RE: Lot 3 Block 4 Unit 19 Volcano Cliffs Subd.

6548 Azor Ln NW

RE: Lot 3 Block 4 Unit 19 Volcano Cliffs 6548 Azor Lane NW Grading and Drainage Plan Engineers Stamp Date 7/9/15 (D10D003T3)

Based upon the information provided in your submittal received 7/9/15, this plan cannot be approved for Grading Permit and Building Permit until the following comments are addressed.

GRADING & DRAINAGE PLAN 6548 Azor Lane, NW LOT 3, BLOCK 4, UNIT 19 VCS

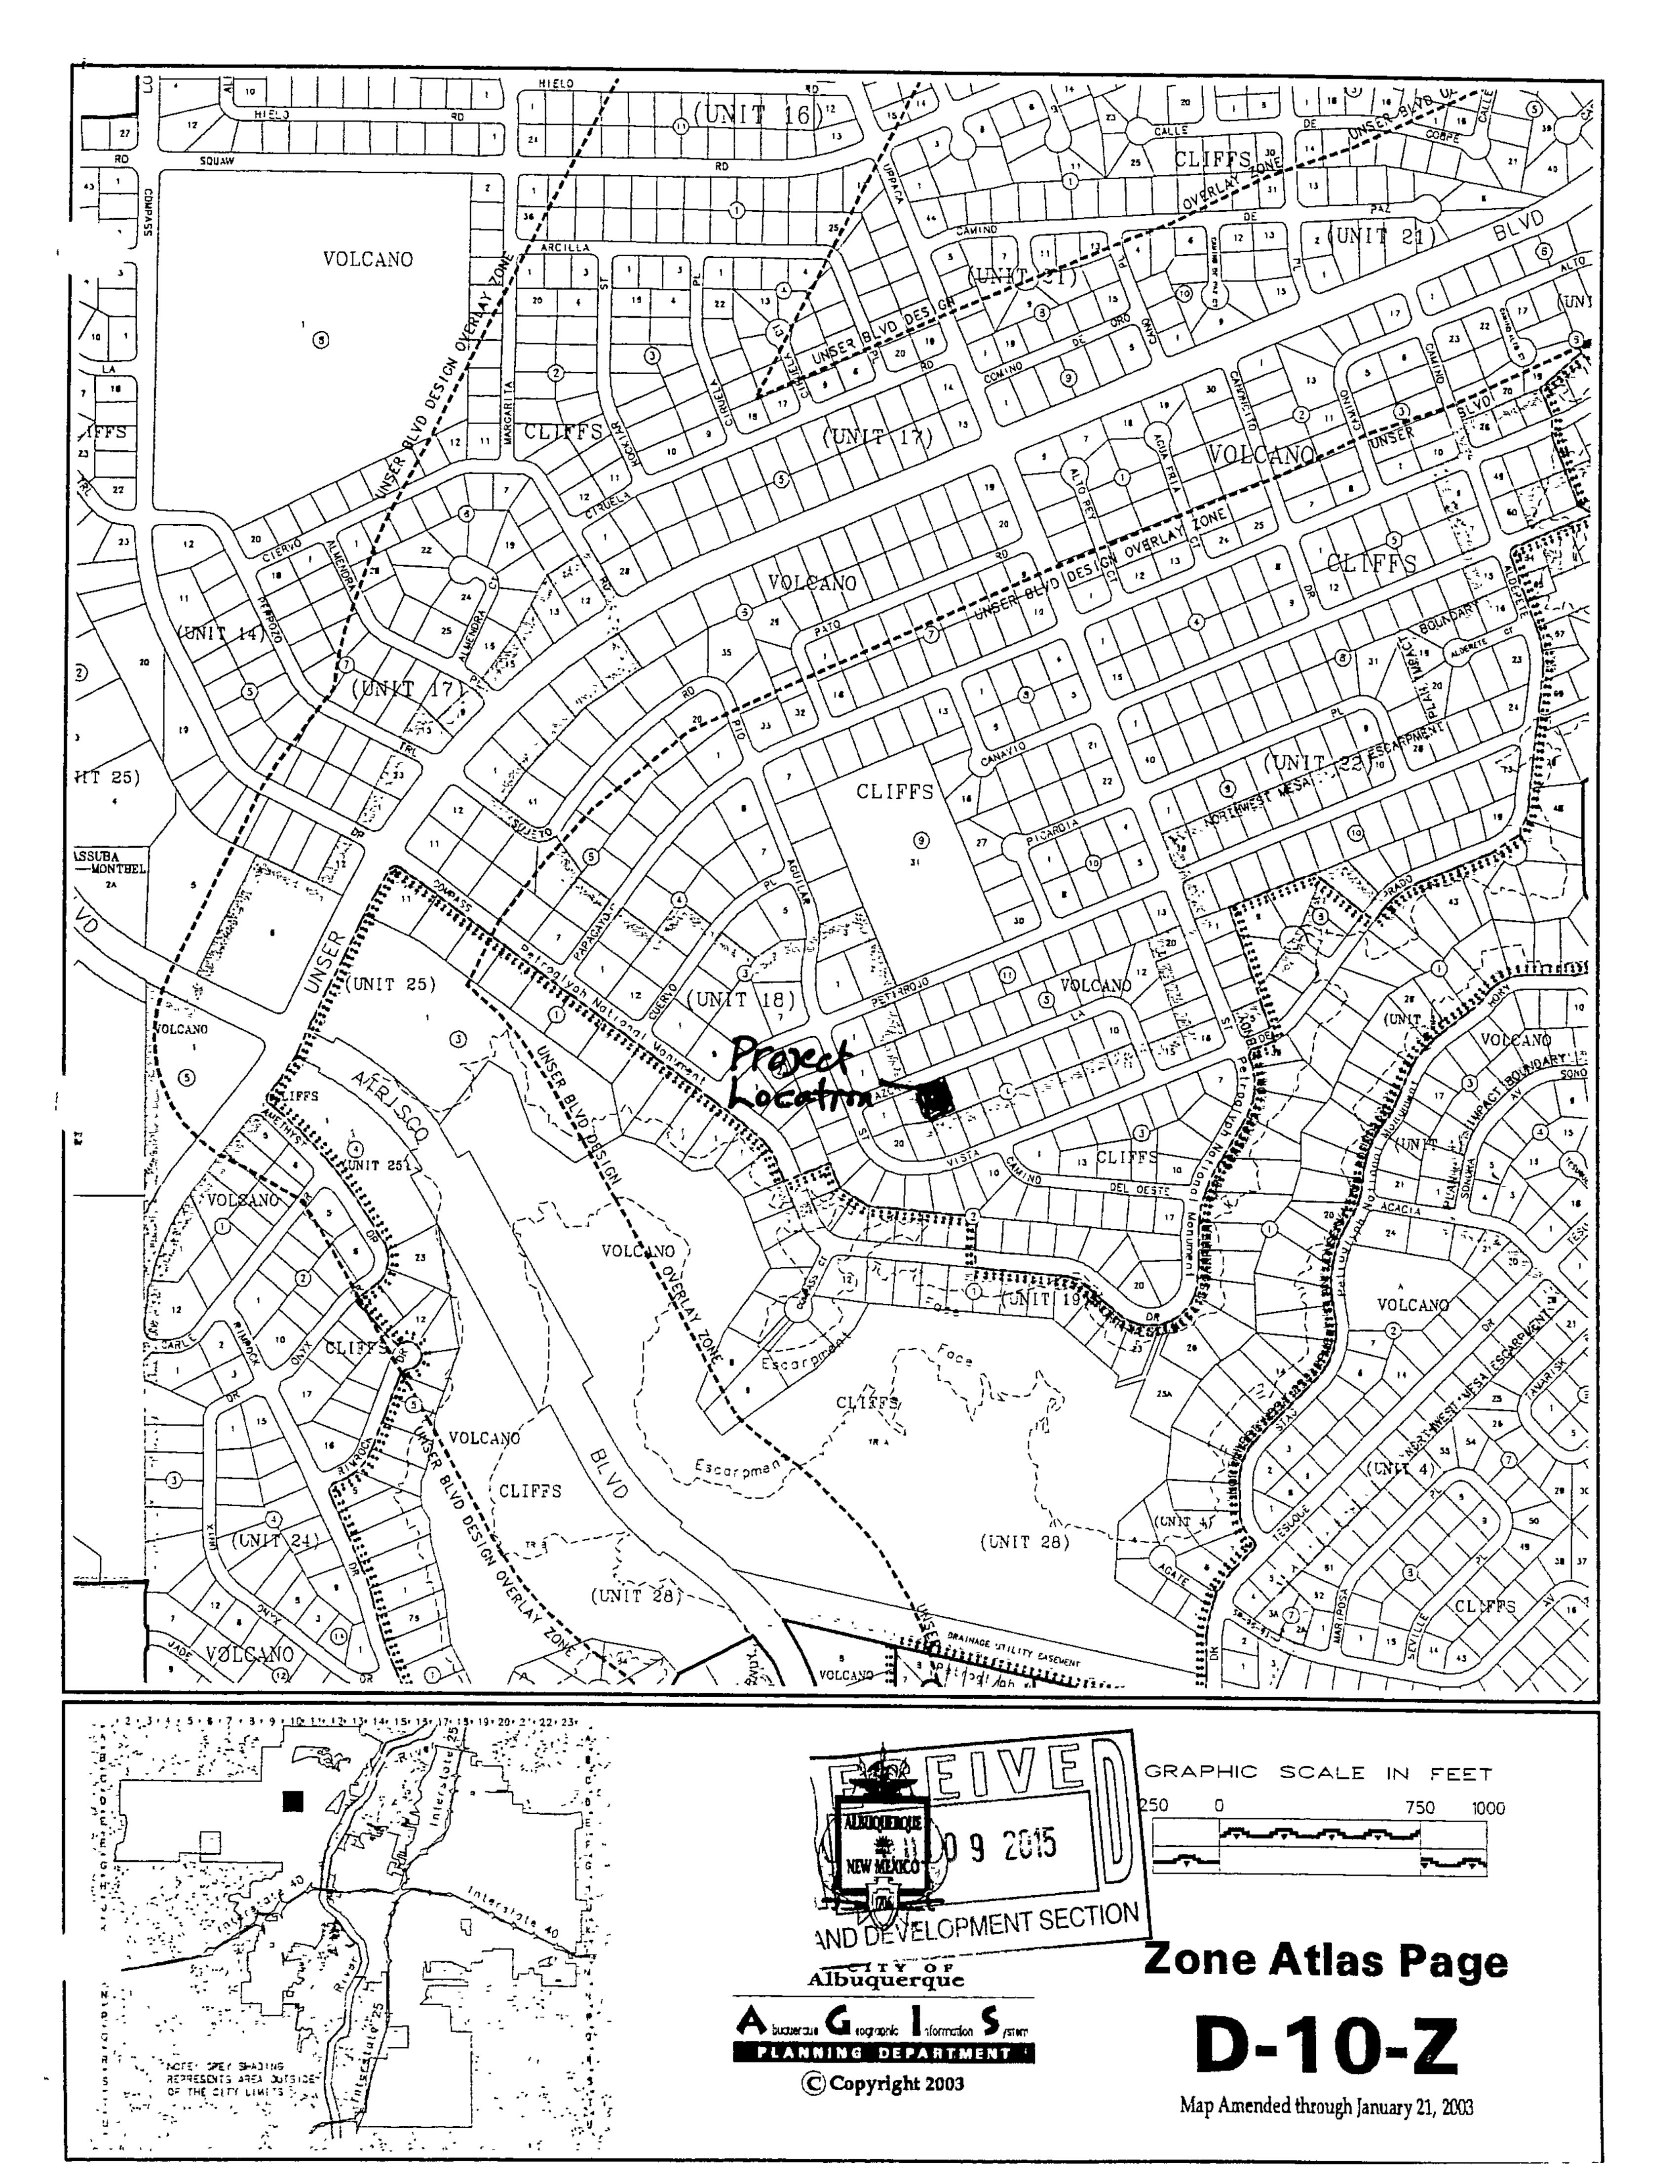
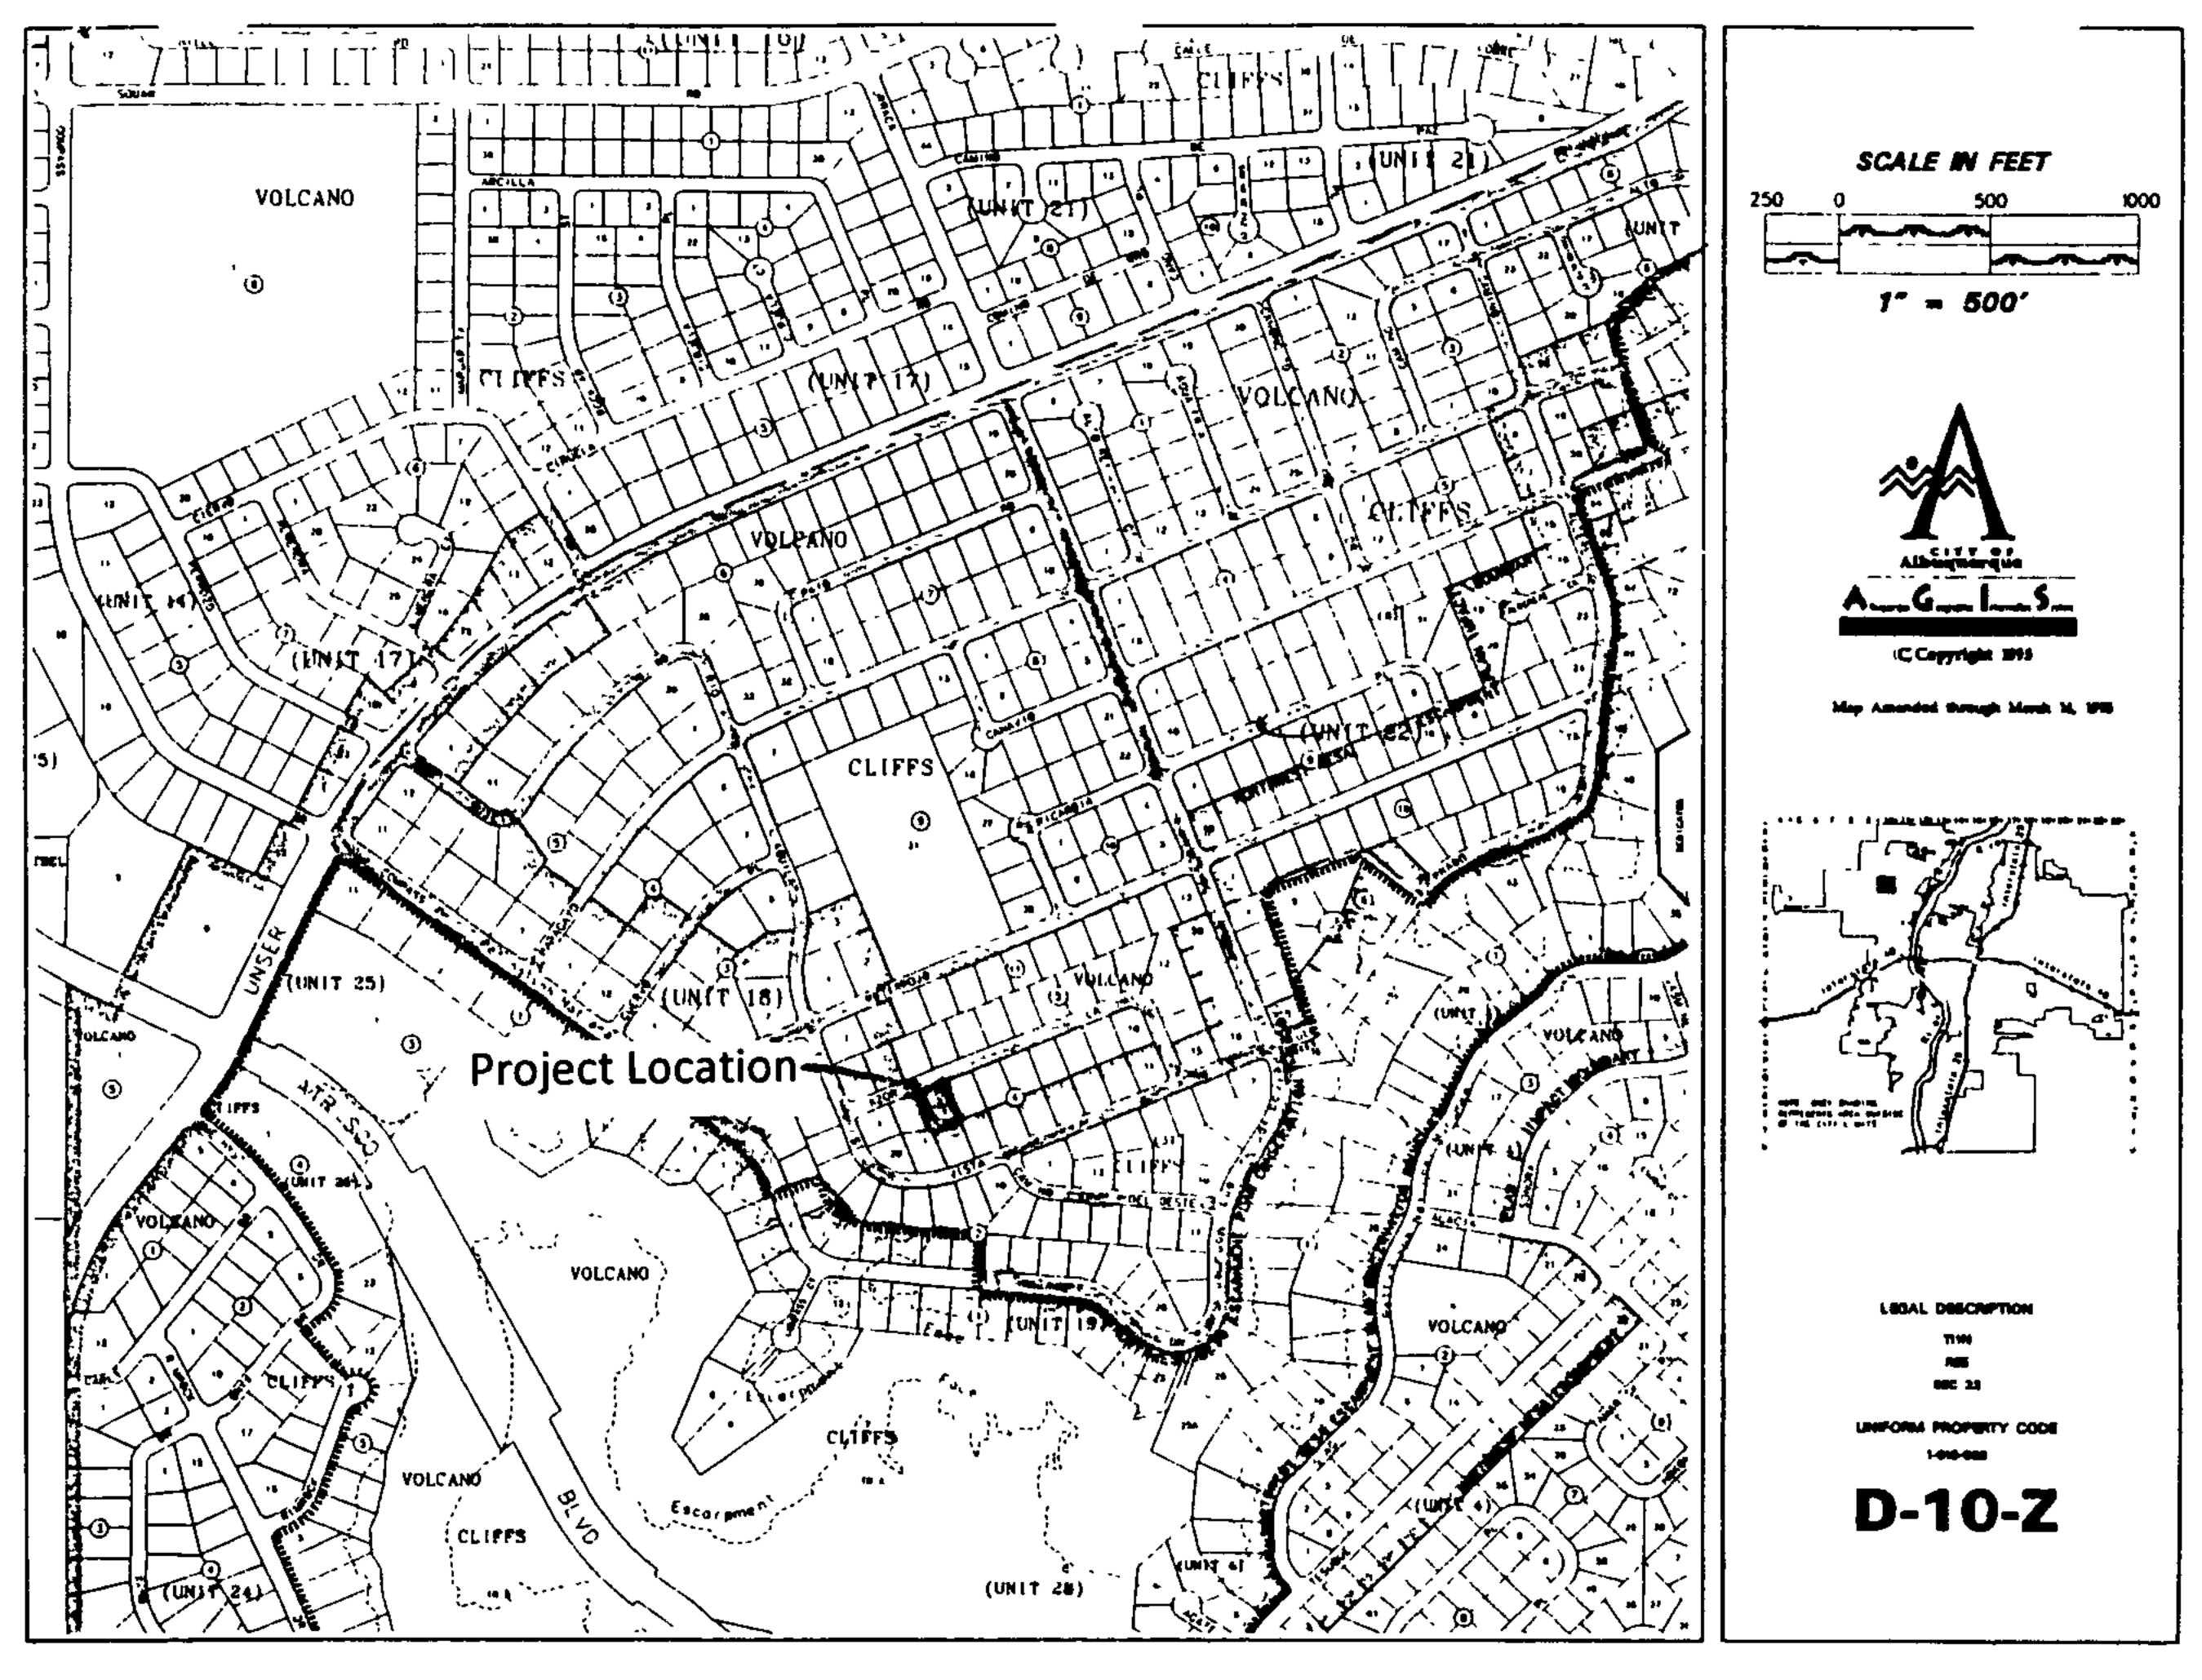
Based upon the information provided in your submittal received 7/9/15, this plan cannot be approved for Grading Permit and Building Permit until the following comments are addressed.

Provide flows for this property which exit out to Azor Street.

• Remove block openings.

• Provide swales from rear yard to front yard both sides of structure.
